REMARKS

AMENDMENTS TO THE DRAWINGS

Annotated Sheet Showing Change

Fig. 7

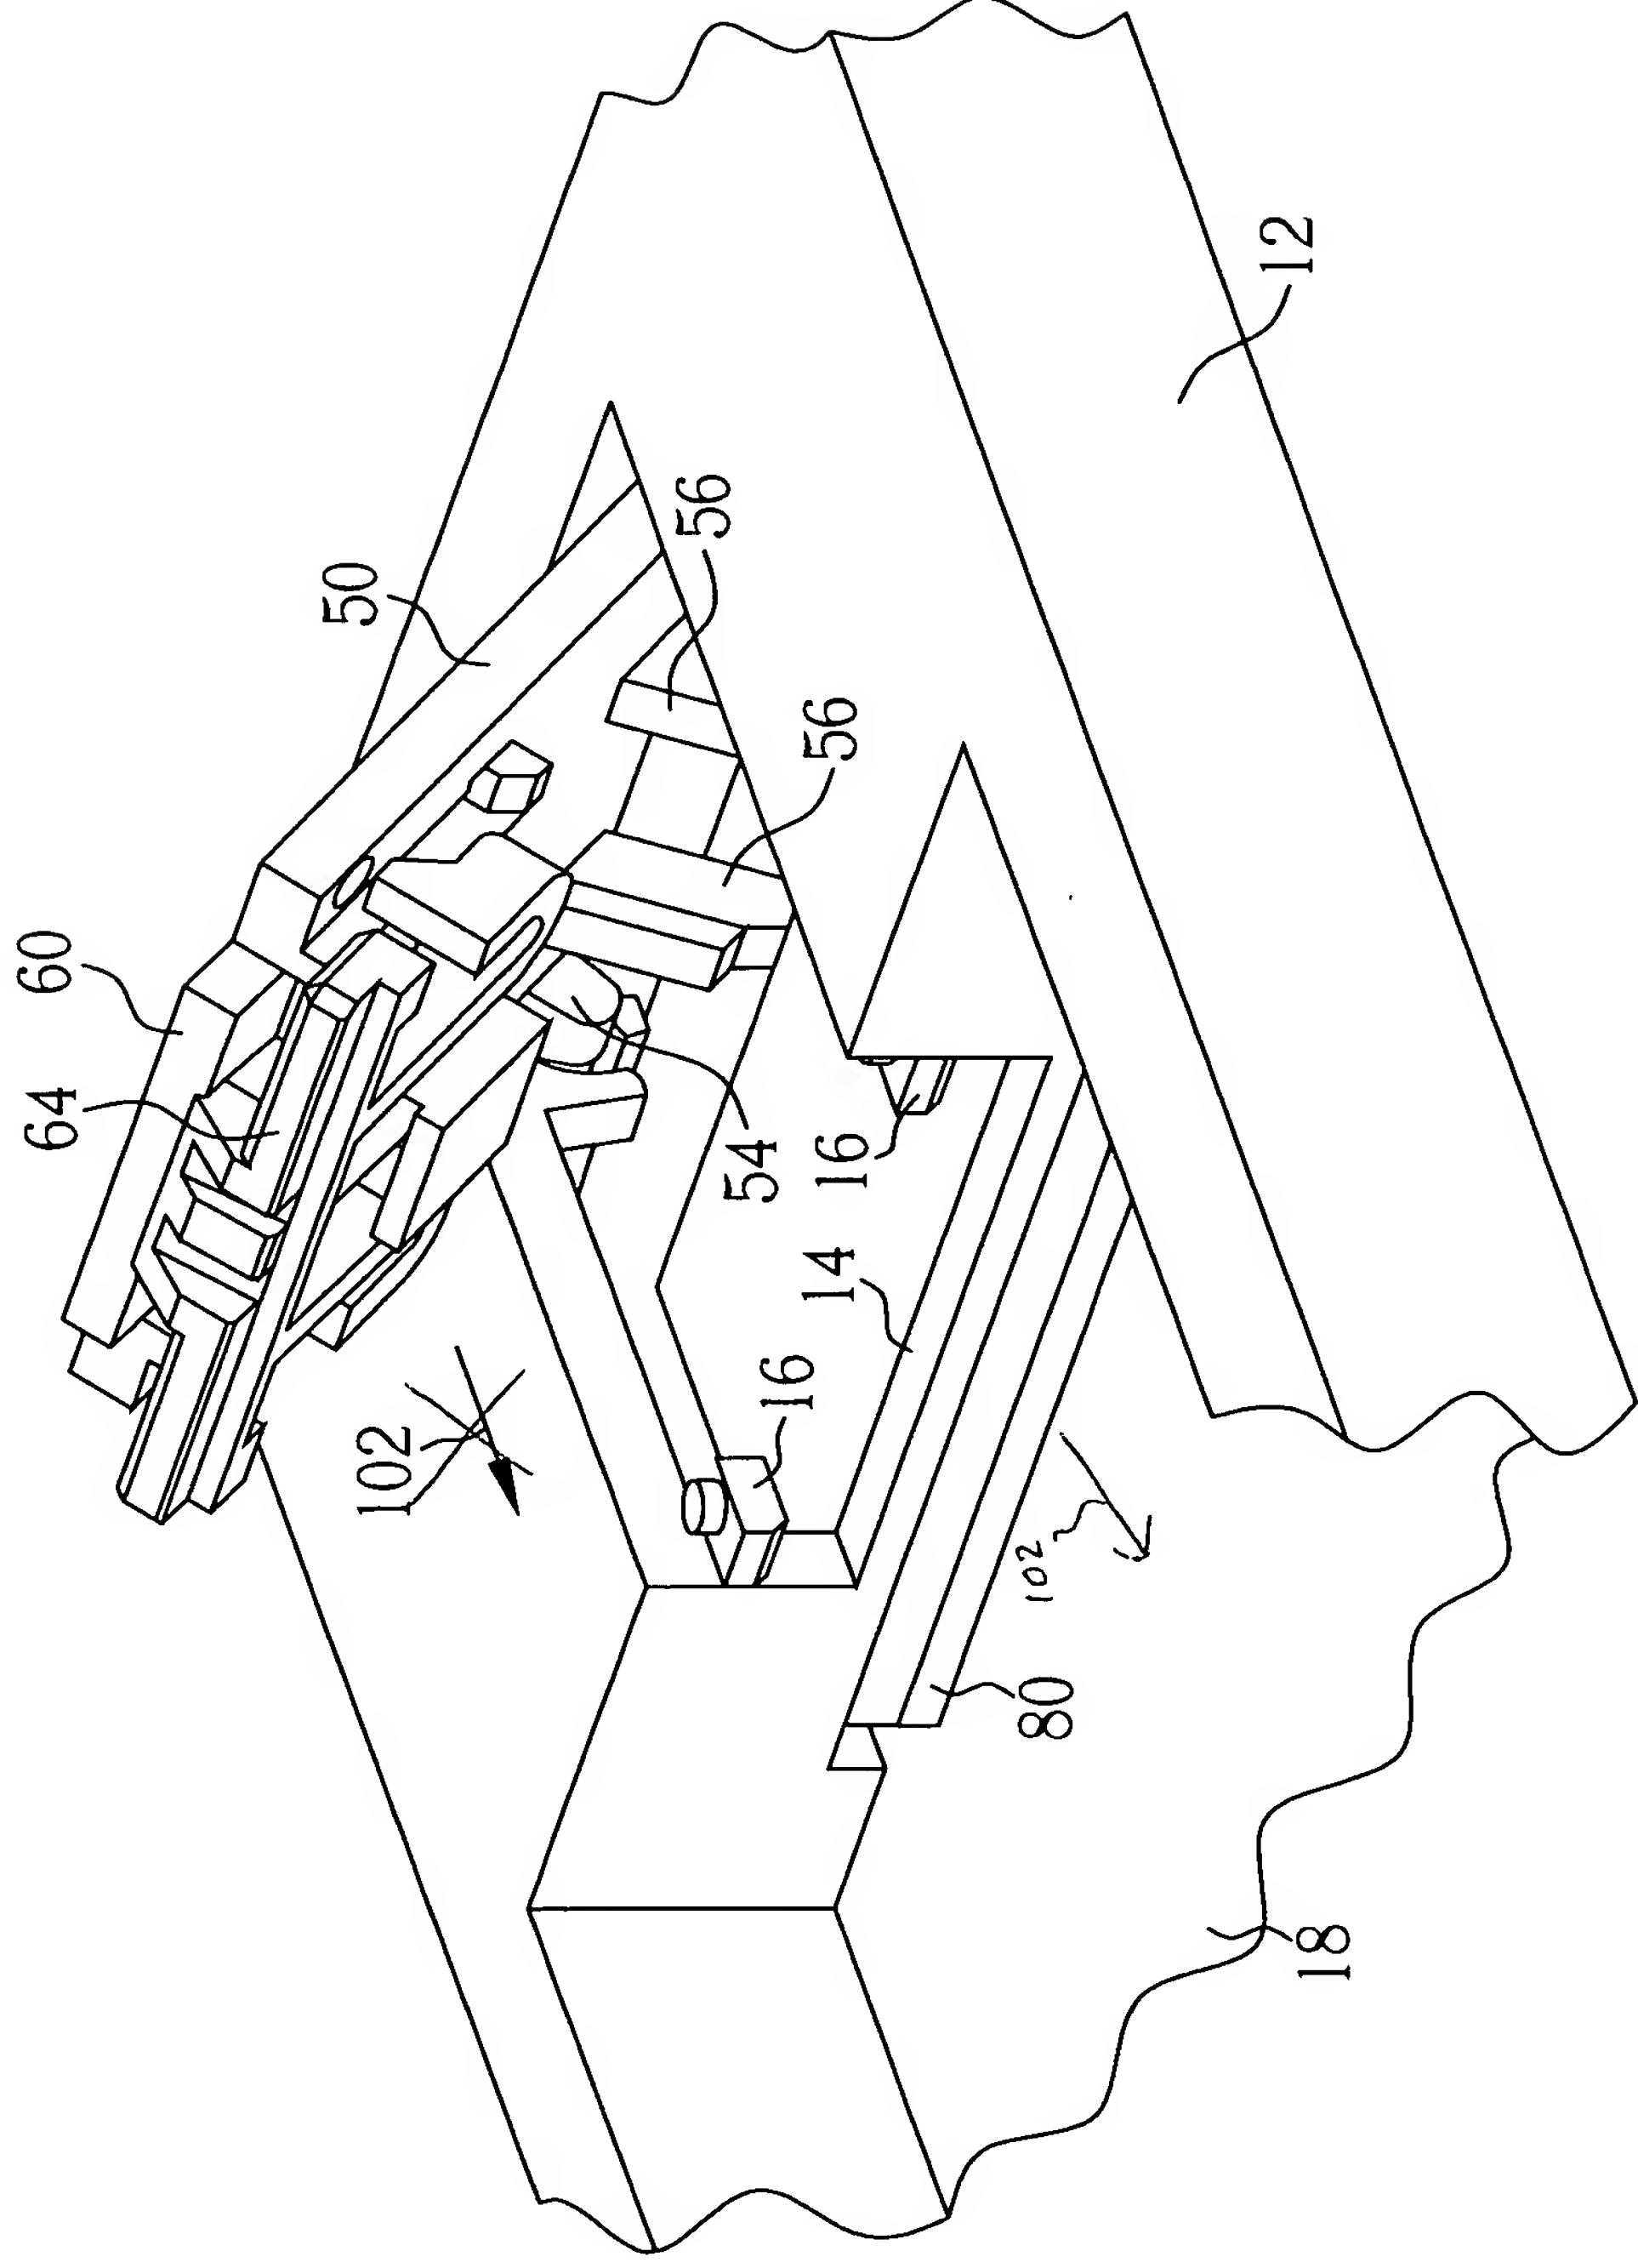
20 The drawings are objected to because: Figure 7, for card 80 an arrow like 102 should be added.

25 The arrow 102 in Fig.2 was originally intended for indicating the direction that the card 80 moves when exiting. To more clearly show this, the arrow 102 has been moved from its original position closer to the card 80. No new matter has been added. Acceptance of the amended drawing is requested.

The attached sheet of drawings includes changes to Fig.7. This sheet replaces the original sheet containing Fig.7. In Fig.7, arrow 102 has been moved closer to the card 80 for more clearly indicating the direction in which the card 80 will exit. No other changes have been made, and no new matter has been added to Fig.6.
